UPDATE PRIOR TO SALE NOTICE

Global Service Action
Number: H557 UPS3925-2

Subject: SVR Rear Bumper Valance not fully retaining to bumper	Publication No.: H557 UPS3925-2
	Model: F-PACE (X761)
	Model Year: 2026
	Date of Issue: 05 August 2025
	Expiry Date: 05 August 2027

E394255

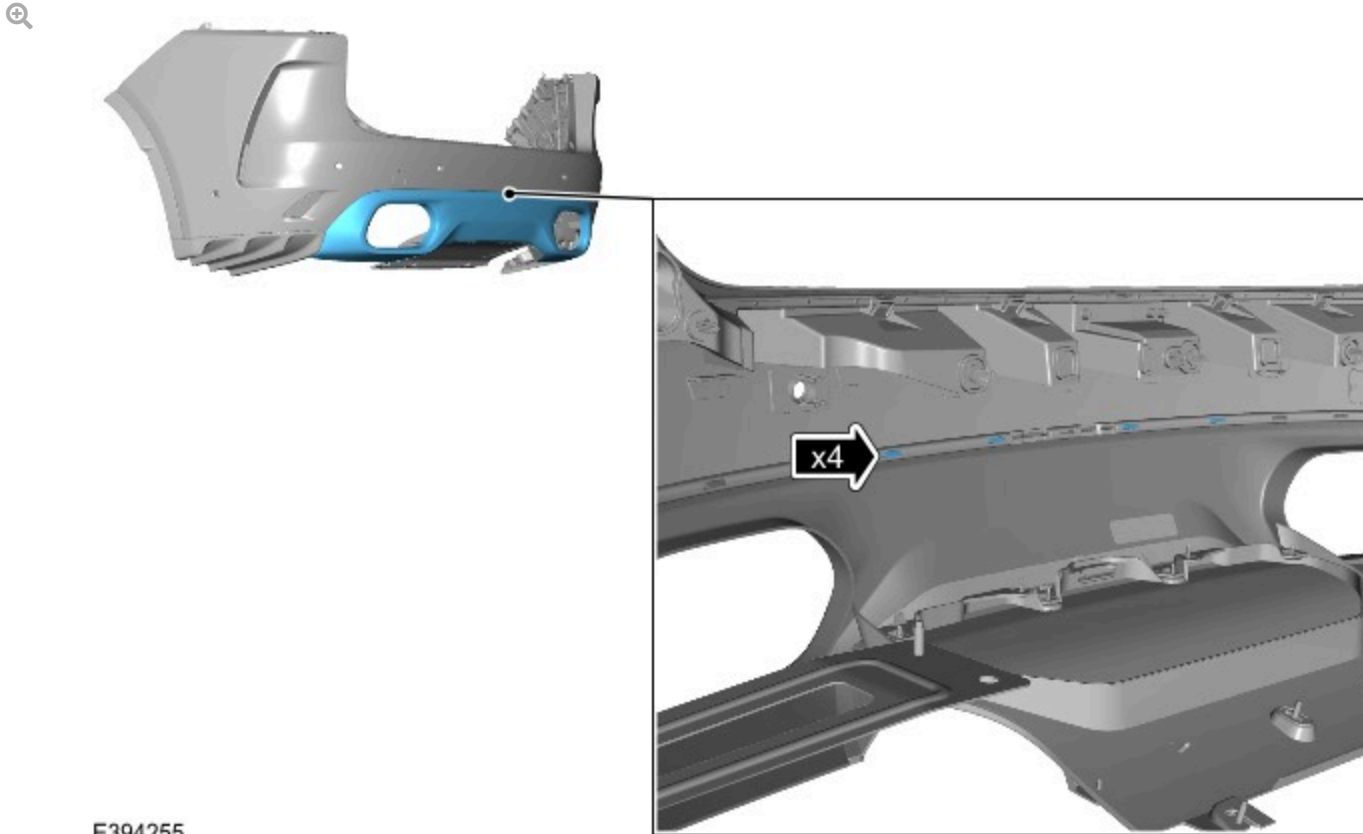
1. The illustration shows the 4 rear bumper valance center clips which may not be securely installed to the rear bumper cover.

E394252

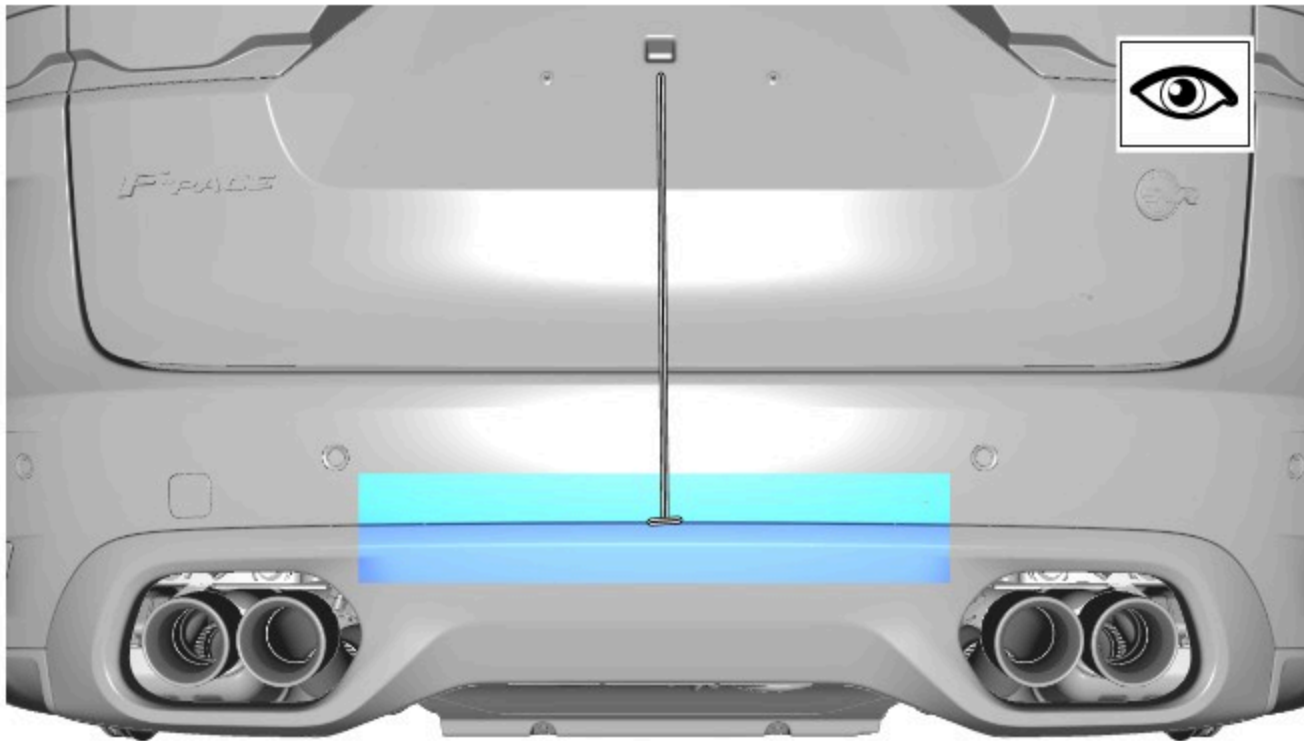
1. Locate the center point of the rear bumper valance to rear bumper cover, as shown in the illustration.

Apply firm, but not excessive, hand pressure to the rear bumper cover in the area identified in the previous step.

- If a visible gap **is** present between the rear bumper valance and the rear bumper cover, as shown in the illustration with the **RED X**, **continue to hold the vehicle**.
- If a visible gap **is not** present between the rear bumper valance and the rear bumper cover, as shown in the illustration with the **GREEN ✓**, **release the vehicle**.
